**MEMORANDUM**

SUBJECT: Action Memorandum  
Yosemite Slough Site, San Francisco, CA  
Site ID # CAN000908486

**Attachment 1: RESPONSIVENESS SUMMARY**  
*EPA Response to Public Comments on the Draft Engineering Evaluation/Cost Analysis*  
**YOSEMITE SLOUGH, SAN FRANCISCO, CALIFORNIA**

Figure 2

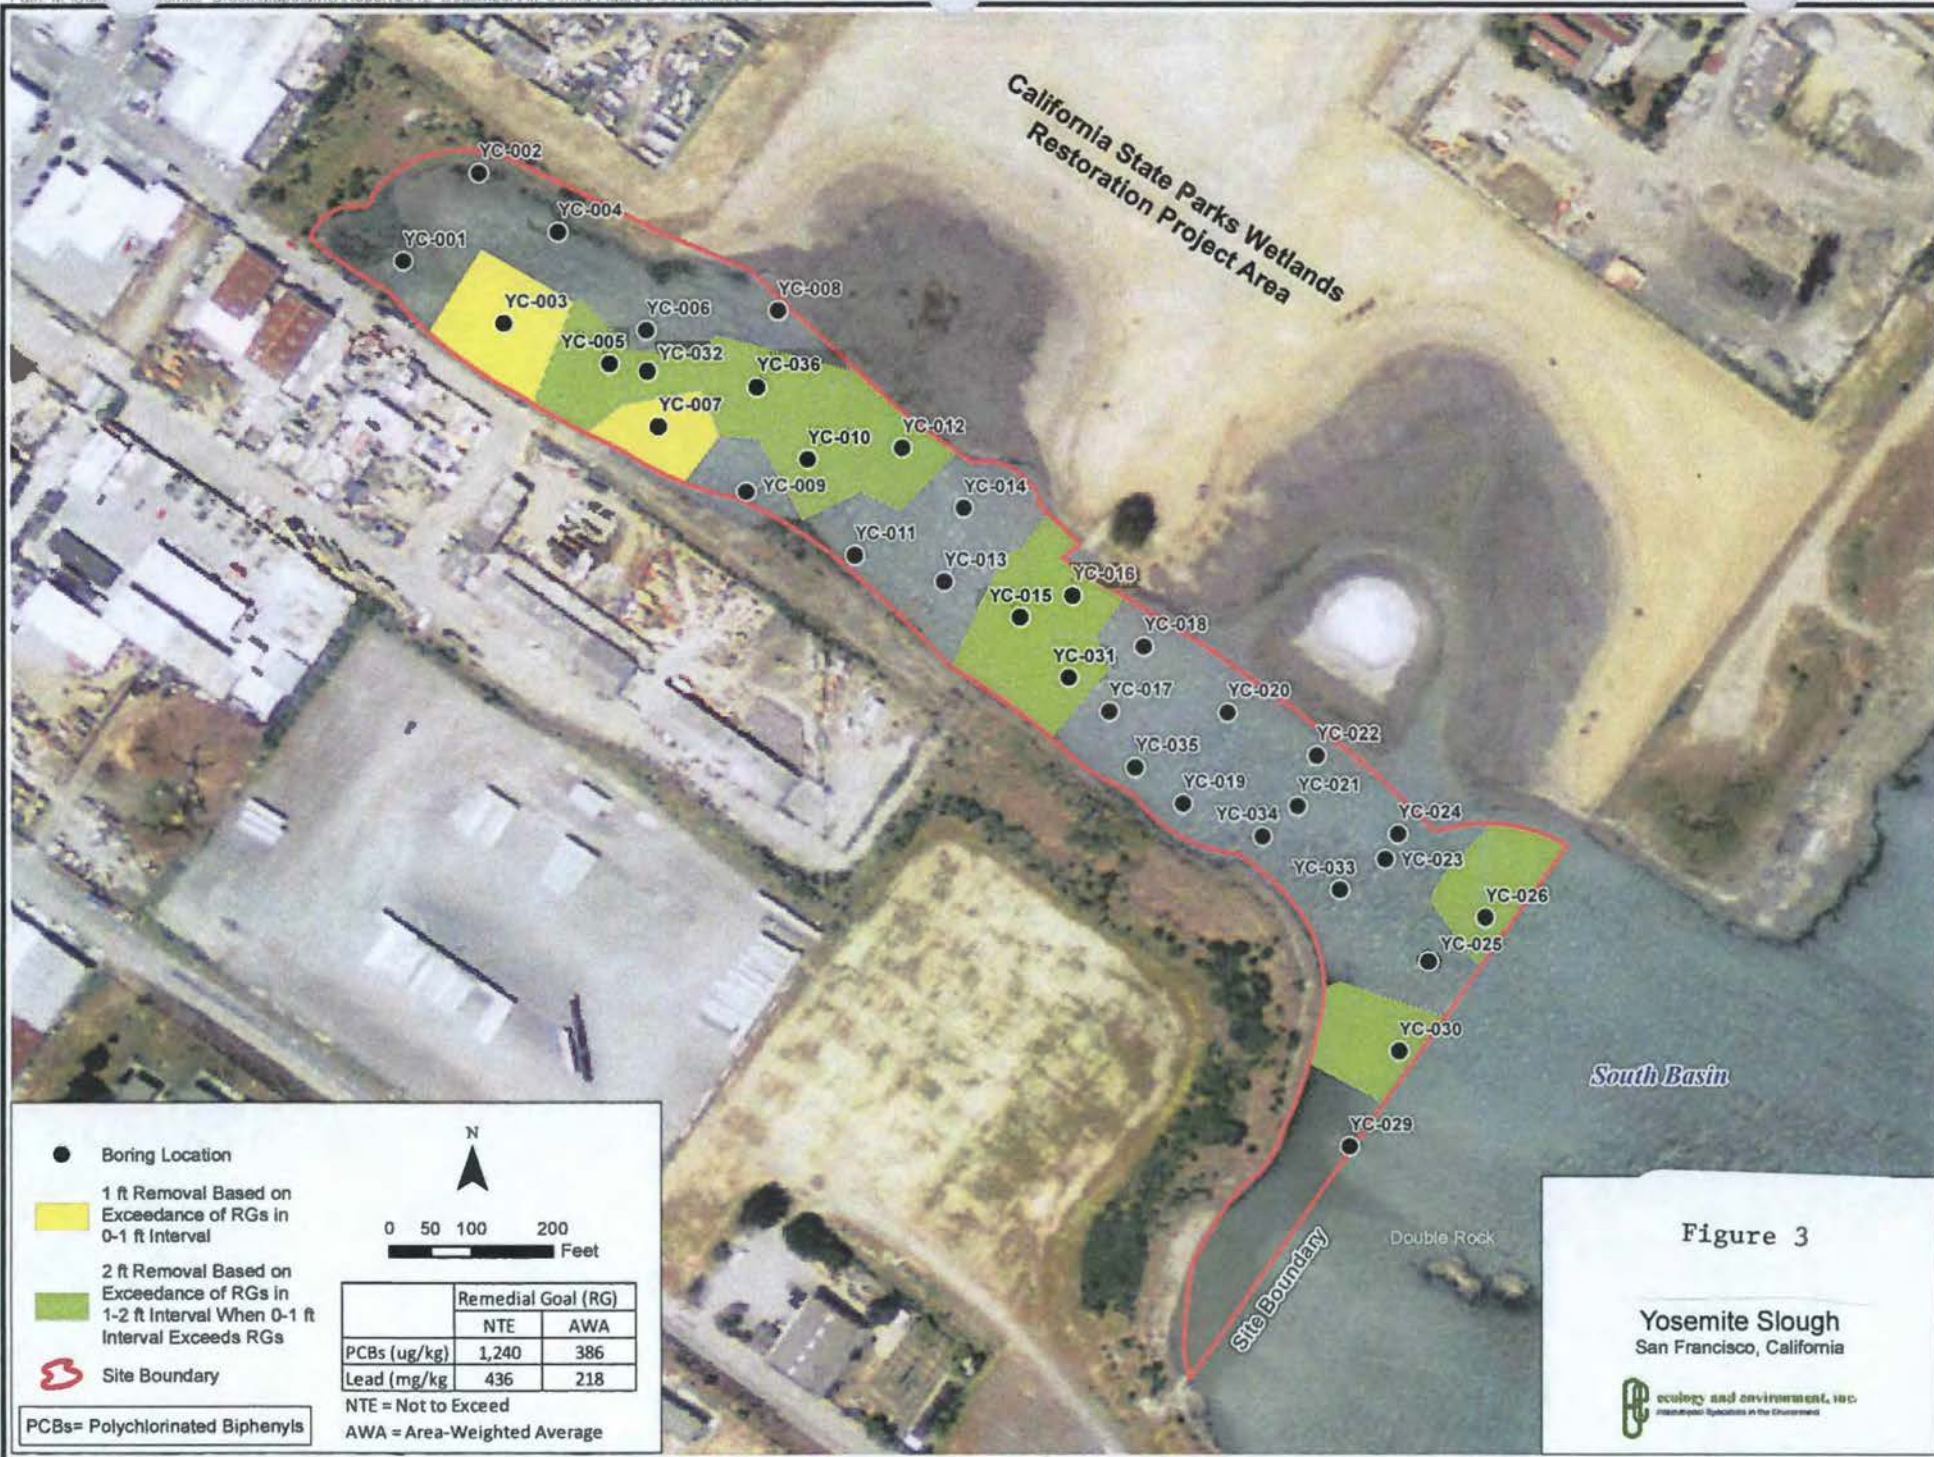
62.	2-1	Figure 2-1	<p><u>Site Location and Description</u></p> <p>Page 2-1 of the EE/CA states the following:</p> <p>"As shown on Figure 2-1, the south, west and north sides of the Site are contiguous with the Candlestick Point State Recreational Area (CPSRA), which is owned or operated by the California Department of Parks and Recreation (CDPR) and the California State Lands Commission (CSLC)."</p> <p>This sentence is inaccurate and should be revised for the following reasons:</p> <ol style="list-style-type: none"> <li>(1) Figure 2-1 lacks sufficient detail to identify the property contiguous to the Site.</li> <li>(2) At the present time, the CPSRA does not completely surround the north, south, and west sides of the Site.</li> <li>(3) Whether the CPSA will completely surround the north, south, and west sides of the Site in the future depends on the occurrence of future land conveyances.</li> <li>(4) The CSLC is not an operator on any of the land contiguous to the Site and has no plans to be an operator on such land in the future.</li> </ol> <p>CSLC staff requests that the EE/CA be revised to further clarify the jurisdiction of the CSLC both in the text and on Figure 2-1.</p>	The EE/CA, Section 2.1, was modified to address this comment and other comments concerning CPSRA and Site ownership.
